EXPERIMENTAL CAVE FOR THE BEER INSTRUMENT AT ESS

PROJECT SPECIFICATIONS AND REQUIREMENTS

Status: Draft
Revision: 1.9
Date: 2024-02-16

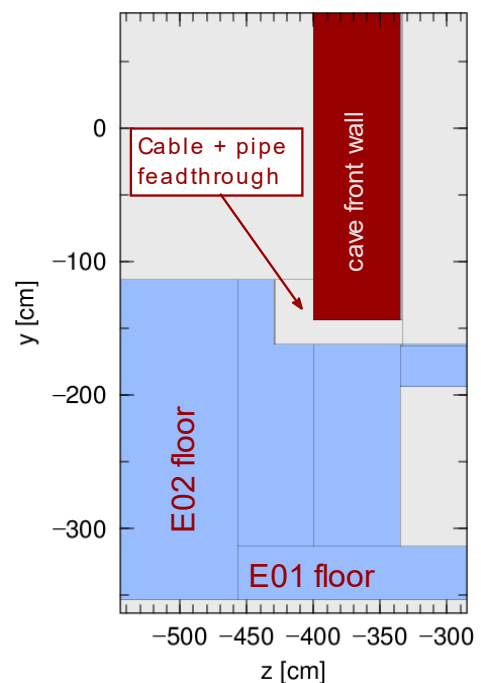
Clarification: The front wall of the cave has to be modified to satisfy the interface with the guide system shielding (interface 5 and requirement R16 in Annex 1). The conceptual design works with intrusion of the last guide shielding block into the front cave wall, but the final design of the shielding expects an extrusion from the cave wall to facilitate the guide shielding installation. The client shall provide the drawings of the interface at the kick-off meeting.

Clarification: The guide system feedthrough (interface 8 and 9, and requirement R17 in Annex 1) design is not fully developed. The redesign of the simple hole to properly accommodate and enable the installation of the guide system feedthrough is necessary. The client shall provide the drawings of the interface at the kick-off meeting.

R24. The chicane wall (interior) located 120 cm in front of the service/personal entry shall be 55 cm thick, 340 cm in length and 250 cm in height, covered on the front end with a steel plate of thickness of 5 cm.

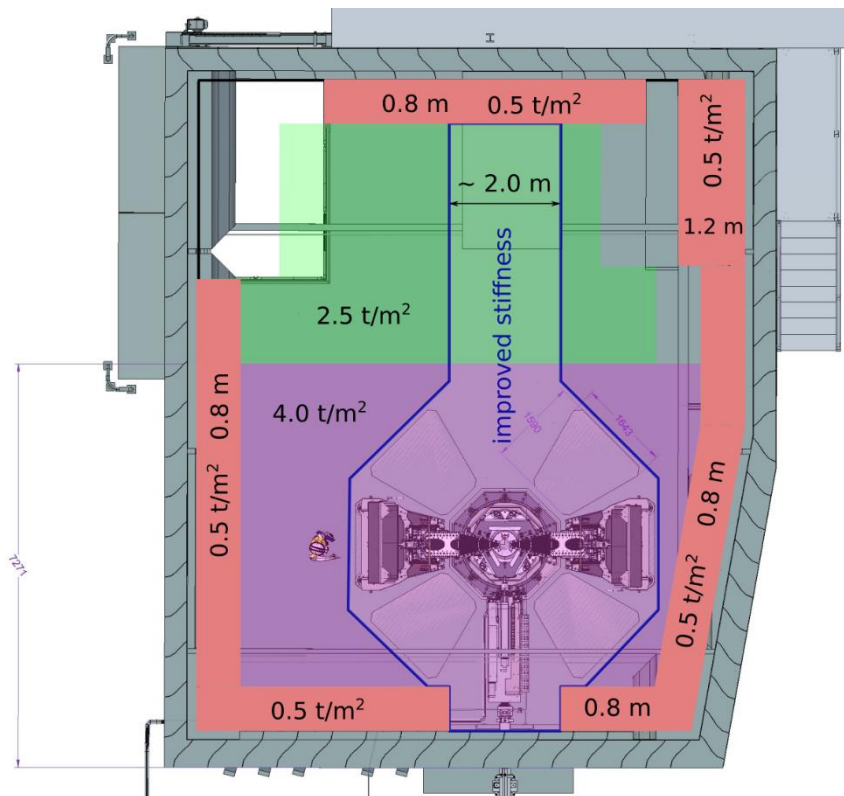
Change request: The chicane should **include a ceiling** made of standard concrete with a thickness of at least 20 cm, covered by a boron shielding layer from the top (1 mm of pure B4C equivalent). The chicane wall length shall be enlarged to **395 cm** (including the 5 cm steel plate).
